- SUBJECTS: 1) EXEMPTION FROM 10 CFR 50.62(c)(4) FOR JAMES A. FITZPATRICK NUCLEAR POWER PLANT, REGARDING THE STANDBY LIQUID CONTROL SYSTEM (SLCS)
- 2) ISSUANCE OF AMENDMENT NO. 116 TO FACILITY OPERATING LICENSE NO. DPR-59 - JAMES A. FITZPATRICK NUCLEAR POWER PLANT, REGARDING SLCS (TAC NO. 69314)

ATTACHMENT TO LICENSE AMENDMENT NO. 116

SAFETY EVALUATION BY THE OFFICE OF NUCLEAR REACTOR REGULATION

RELATED TO AMENDMENT NO. 116 TO FACILITY OPERATING LICENSE NO. DPR-59

FIG. 3.4-1

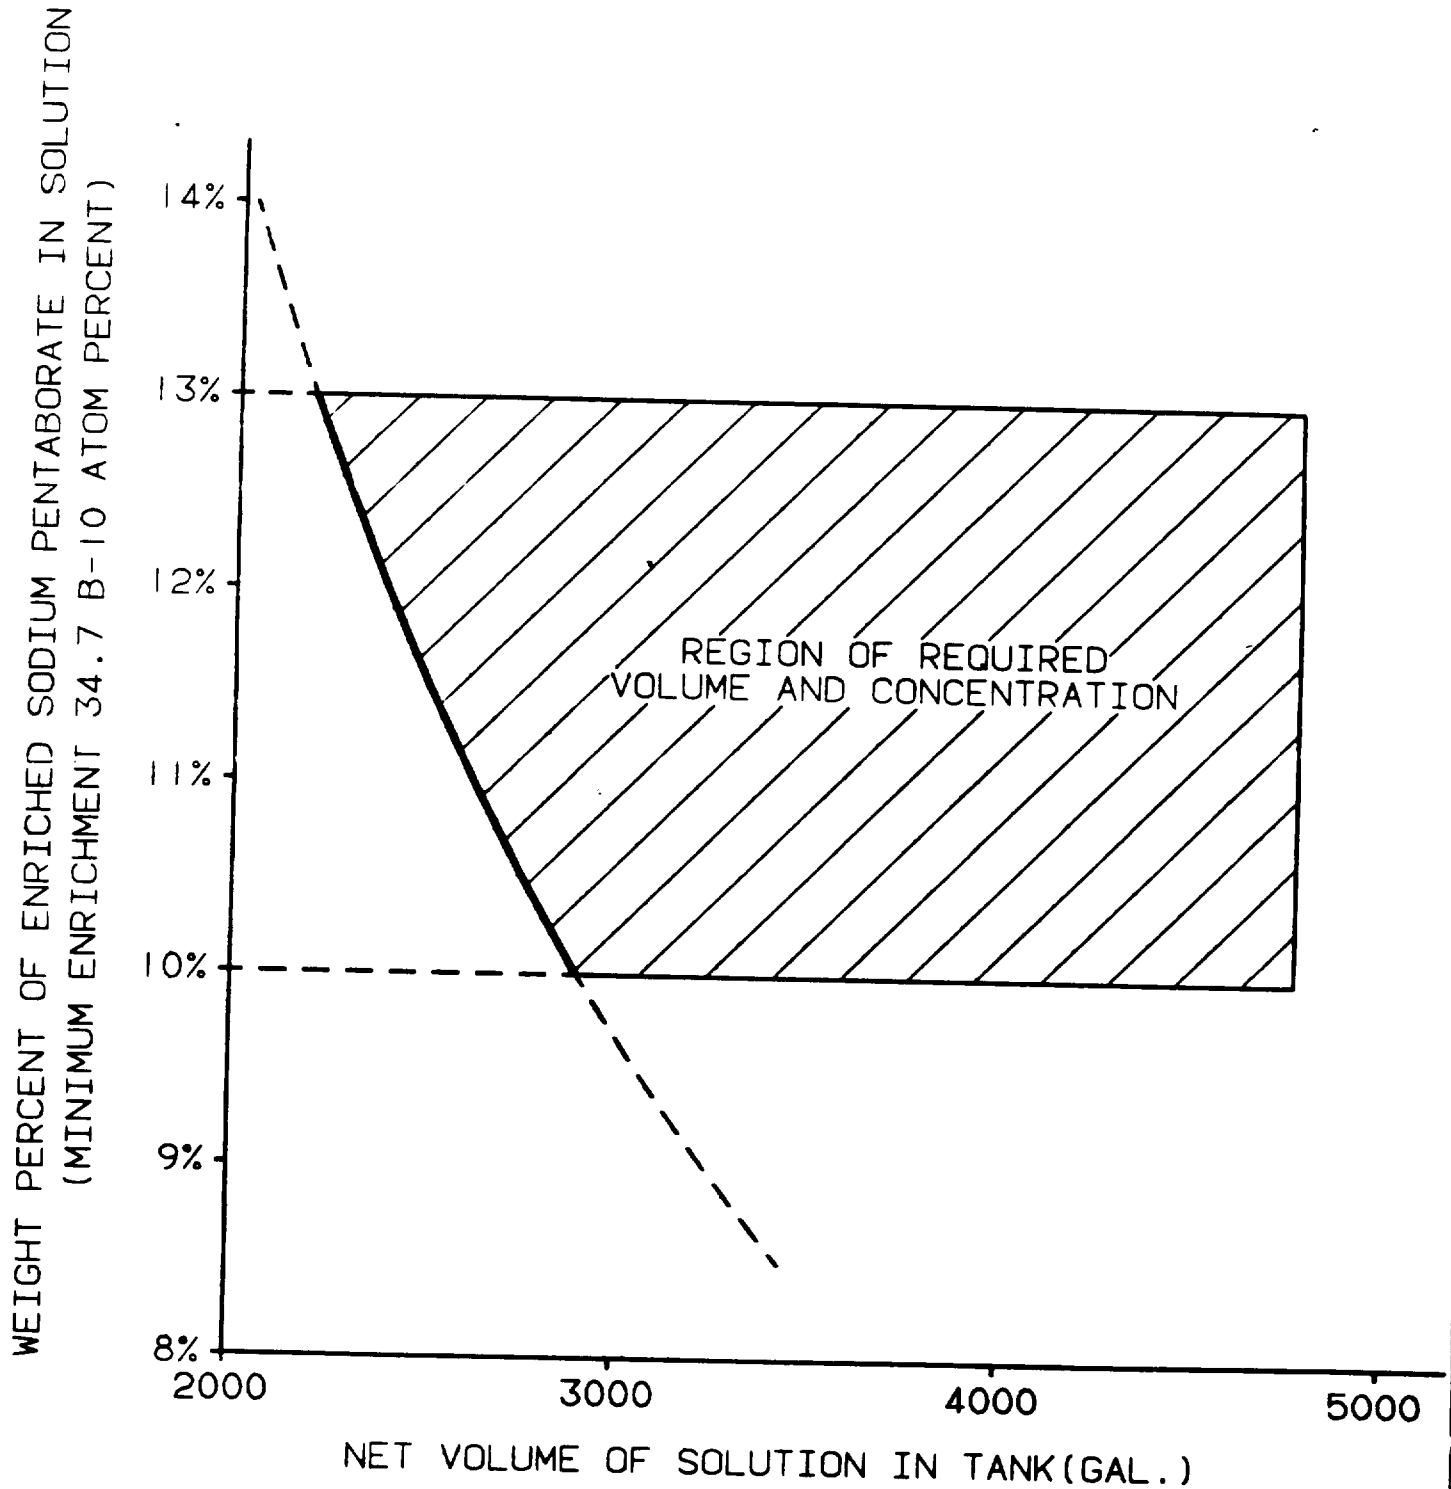
The proposed TS changes are intended to meet the requirements of the ATWS Rule, 10 CFR Part 50.62(c)(4). The ATWS Rule requires that the SLCS be equivalent in control capacity to a system with an 86 gpm injection rate, using 13 weight percent unenriched sodium pentaborate solution, in a system with a 251 inch diameter reactor vessel. Of the several proposed approaches presented in the General Electric report (Ref. 1), and approved in the NRC evaluation (Ref. 2), the licensee has chosen to use enriched (in B-10) boron. Using the calculation methods of Reference 1 allows a minimum concentration of 11.5 weight percent sodium pentaborate when using an enrichment of 34.7 atom percent B-10, an injection rate of 50 gpm and a water mass of 491,700 pounds (218 inch vessel). The new limits are reflected in the revised TS Section 3.4.C and Figure 3.4-1.

The standby liquid control solution tank shall contain a boron bearing solution with a minimum enrichment of 34.7 atom percent of B-10 that satisfies the volume-concentration requirements of Fig. 3.4-1 at all times when the Standby Liquid Control System is required to be operable and the solution temperature including that in the pump suction piping shall not be less than the temperature presented in Fig. 3.4-2. Tank heater and the heat tracing system shall be operable whenever the SLCS is required in order to maintain solution temperature in accordance with Fig. 3.4-2.

Figure 3.4-1 shows the permissible region of operation on a sodium pentaborate solution volume versus concentration graph. This curve was developed for 34.7% enriched B-10 and a pumping rate of 50 gpm. Each point on this curve provides a minimum of 660 ppm of equivalent natural boron in the reactor vessel upon injection of SLC solution. At a solution volume of 2200 gallons, a weight concentration of 13% sodium pentaborate, enriched to 34.7% boron-10 is needed to meet shutdown requirements. The maximum storage volume of the solution is 4780 gallons which is the net overflow volume in the SLC tank.

**FIG. 3.4-2**

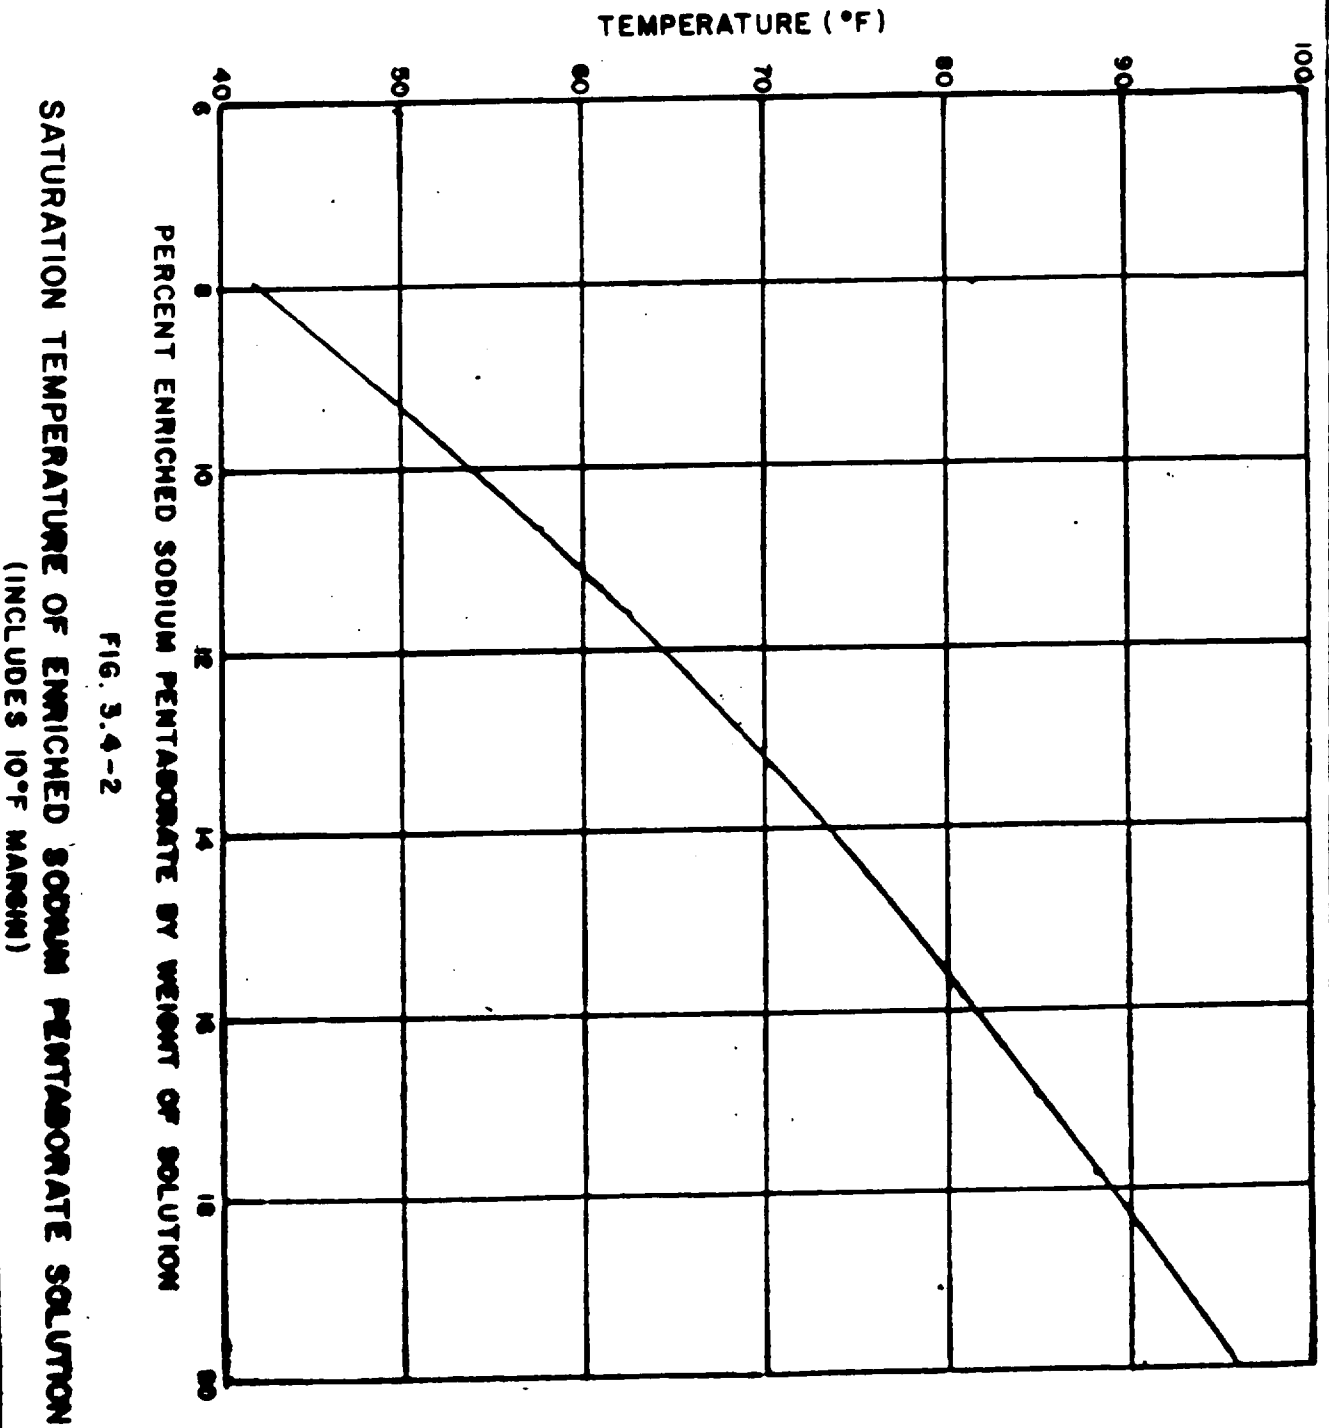
The licensee's submittal stated that surveillance and positive verification will be performed periodically (once per month) to assure that the correct boron concentration is maintained. When additional chemicals, e.g., boron or boric acid are added to the storage tank, or if the solution temperature drops below specified limits, the boron concentration will also be verified (TS Section 4.4.C). The enrichment of B-10 will be checked at least once per operating cycle. Periodic verification of the 50 gpm flow rate is also performed (TS Section 4.4.A). The temperature-concentration requirements of existing Figure 3.4-2 are unchanged; however, the Figure is revised to reflect

an editorial change in the title. The aforementioned surveillance requirements provide reasonable assurance that an adequate neutron poison level will be maintained, are consistent with previously reviewed specifications, and are, therefore acceptable. The bases to Technical Specification 3.4 and 4.4, which were revised to reflect the proposed changes, are also acceptable.

To guard against precipitation, the solution, including that in the pump suction piping, is kept at least 10°F above saturation temperature. Figure 3.4-2 shows the saturation temperature including 10°F margin as a function of sodium pentaborate solution concentration. Tank heater and heat tracing system are provided to assure compliance with this requirement. The set points for the automatic actuation of the tank heater and heat tracing system are established based on the solution concentration. Temperature and liquid level alarms for the system annunciate in the control room. Pump operability is checked on a frequency to assure a high reliability of operation of the system should it ever be required.
